TO: City of Gainesville
Development Review Board

Item Number: 2

DATE: September 27, 2016

SUBJECT: Petition DB-16-97 SPL: CHW, Inc. (Holly Simon), agent for Garrison SW 17th Avenue, LLC., owner. Major development plan review to allow the construction of a hotel. Zoned: UMU-2 (10—100 units/acre, and up to 25 additional units/acre by special use permit, urban mixed-use district). Located at the 3700 block of SW 17th Avenue (Hull Road Extension).

MAP 3.
Aloft Hotel Development Plan

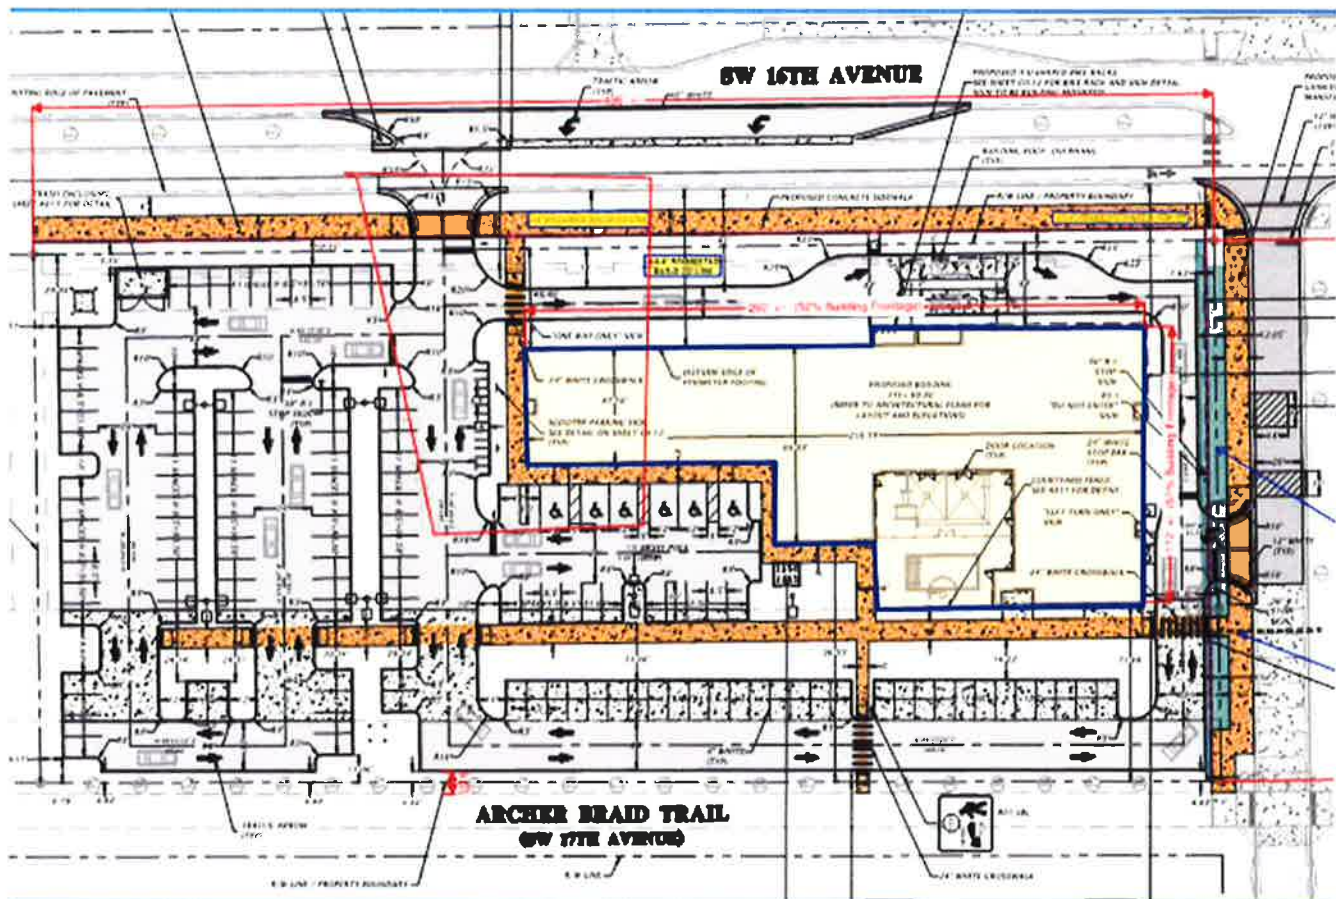
The building does not satisfy the 70% frontage exposure along any of the adjoining streets. The building frontage is about 52% along both the pedestrian Urban Walkway and the other roadways. The limitations to compliance are due to the type of use, the narrow width of the property and the existence of very large and wide easements traversing the property. A waiver from the 70% building frontage is requested which staff supports.

The development does not meet the build-to line requirement on any of the street frontages. The inability to meet the standard along the southern roadway, the Urban Walkway, is due to the existence of easements over which buildings are prohibited. The building is pushed back along the east and north roadway frontages to make allowance for driveways and entry access to the building.

In terms of building entrance, the development complies with the UMU-2 requirements on all sides except the north side facing Hull Road Extension. There is only one entrance along the north side which spans a distance of more than 150 feet. This requirement is not included because of the nature of the use and the need to facilitate safety of patrons; it is also the side where the major entrance is located.

A functional system of sidewalks provides an efficient network of routes to facilitate pedestrian circulation internal and external to the development. In addition to the routes displayed, a north/south route is planned along the western boundary of the development to facilitate connectivity across the street block between SW 37th and 38th Streets.

A minimum four-foot wide north/south corridor shall be reserved along the western boundary of the development with cross-access easements to facilitate construction and use of a north/south sidewalk between the subject development and future developments to the west.

Map 3.
Required Street Cross-section for Local Streets

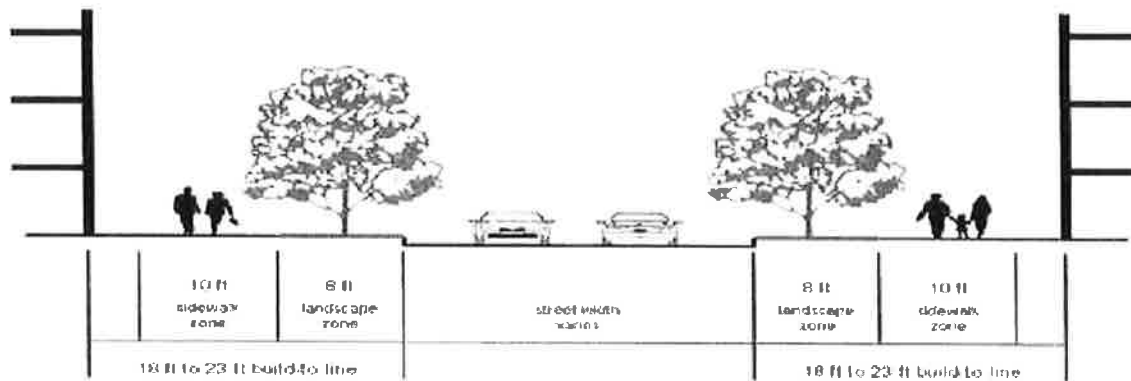
One of the main objectives of the UMU-2 district and Urban Village is to promote multimodal transportation and create high-quality urban streetscapes by using buildings, sidewalks, and street trees to form a pleasant, convenient and safe environment designed for pedestrians, bicyclists, public transit, and automobiles. Some of the most important implementation strategies are the standards required to facilitate pedestrian use and circulation associated with the development. The applicant is providing 50% of the 40 bicycle parking spaces required for the project. The basis of the request is the type of use. The applicant claims that very little patron traffic arrives via bicycle and that the number required is too high. The bicycle parking provided is distributed throughout the site making it easy for cyclist using the facility, to easily access the development. Staff supports the requested waiver.
